Remarks/Arguments

Rejection of Claims 37-42, 44, 46, 50-52, 54-57, 59 and 60 under 35 U.S.C. 102(b) as being anticipated by Lai et al. (6,224,472).

FIGURE 3A

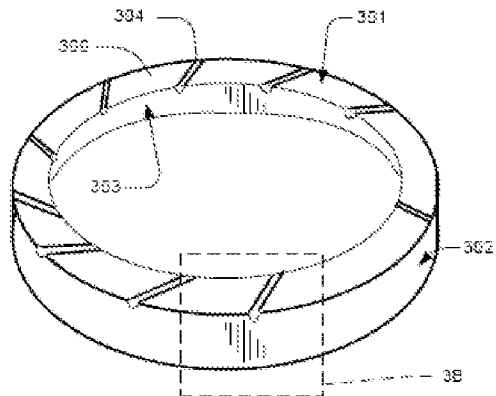
Parent Claim 37 is amended to state “ at least a portion of said first groove not adjacent to the lower surface has a rounded cross-sectional contour along substantially the entire length of said first groove;” For support see figures 3A and 3B.

Claim 37, lines 6 – 8 is amended. For support see claims 39 and 40, see figs 3A, 3B, 4A. This amendment further clarifies what was already claimed and is not a further narrowing of the claim.

Claim 39 is amended. For support see figures 3A, 3B, and 4A. The first inner and outer peripheral openings shown in the figures are implicit in the previous claim 39 limitation “said plurality of grooves only communicate between said inner peripheral surface and said outer peripheral surface;”.

FIGURE 4B

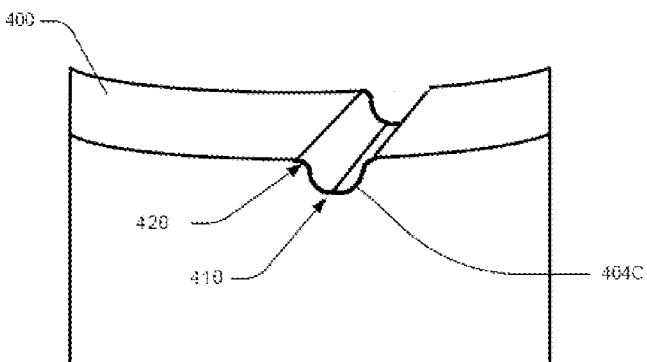
Claim 44 is amended. For support see figures 4A, 4B and 4C.

Dependent claim 59 is amended. For support see claims 56 and 57; See figure 4A, 4B and 4C.

Embodiment with rounded top corners – see e.g., claim 43

FIG. 12

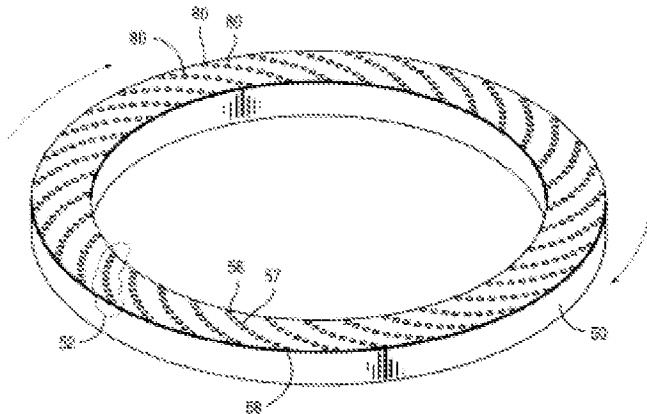
Lai figure 18 shows “dimples” 80 is a cross-sectional view. As shown in top down view Lai figure 12, these dimples only extend across a portion of the Lai retaining ring. (see Lai col. 14, L 21-23;). Lai’s dimples 80 do not extend to either the inner peripheral surface of the ring or to the outer peripheral surface of the ring. See Lai figures 18 and 12. The dimples stop before touching/meeting/joining with the peripheral surfaces. That is there is top surface space between the dimples 80 and the peripheral surface. Therefore Lai does not meet or suggest applicant’s parent claims 37 50 and 55.

Lai Figure 12 clearly shows the dimples 80 do not extend from the inner peripheral surface to the outer peripheral surface of the ring. Therefore figure 12 does not meet the applicant's parent claim limitations.

Even if it is argued that Lai figure 12 shows a plurality of grooves 52 (two or more grooves), these dimples 52 do not extend to the peripheral surface. The two or more dimples only extend part way between the peripheral surface. It is improper to interpret the imaginary line 52 as the "plurality of grooves" in applicant's unamended claim 37. Unamended claim 37 did not state that "**an imaginary line around the plurality grooves extends from said inner peripheral surface to said outer peripheral surface.**"

Chen (Marked up) figure 14 clearly shows Chen's grooves are in the CMP pad, not in a retaining ring.

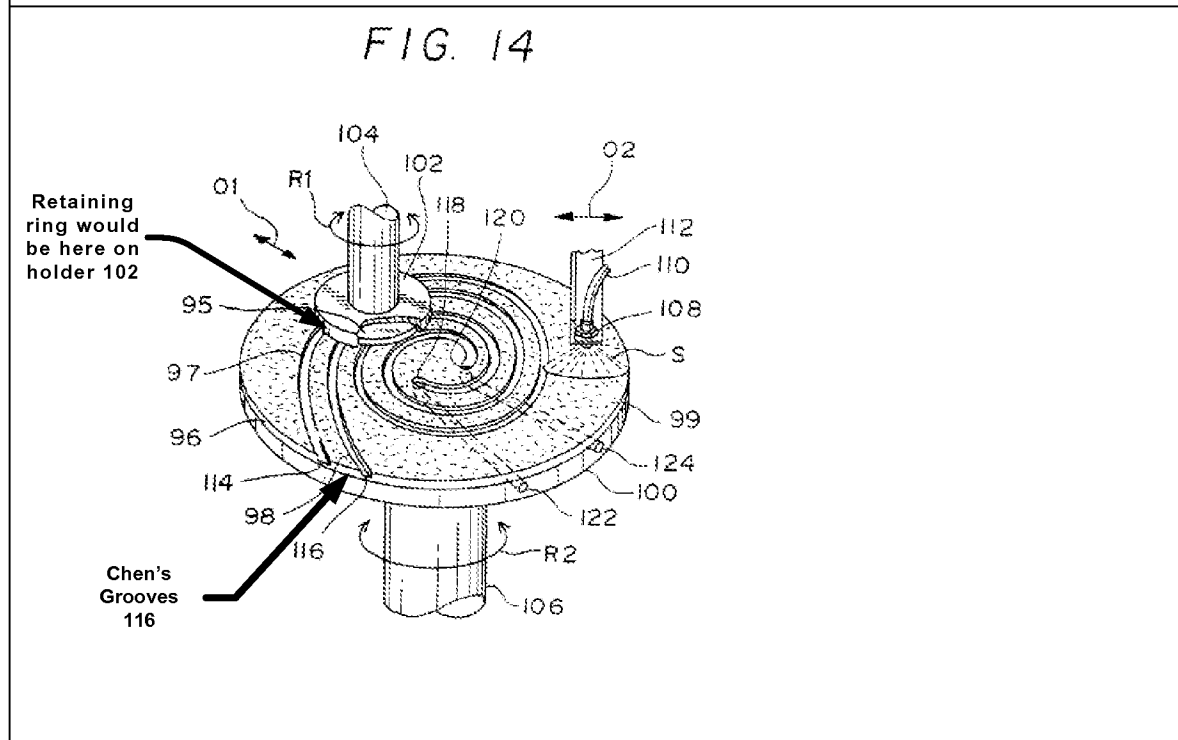
Applicant respectfully posits that this is a misinterpretation of Chen (Chen et al. 10:08-13). Chen shows only grooves in a CMP pad. Nowhere in Chen does discuss retaining rings. Chen makes no suggestion to put grooves in retaining rings. Moreover, Chen figure 14 teaches against putting grooves into retaining rings by showing a cut away view of a CMP holder 102 that does not have any grooves in the surface that contacts the CMP pad.
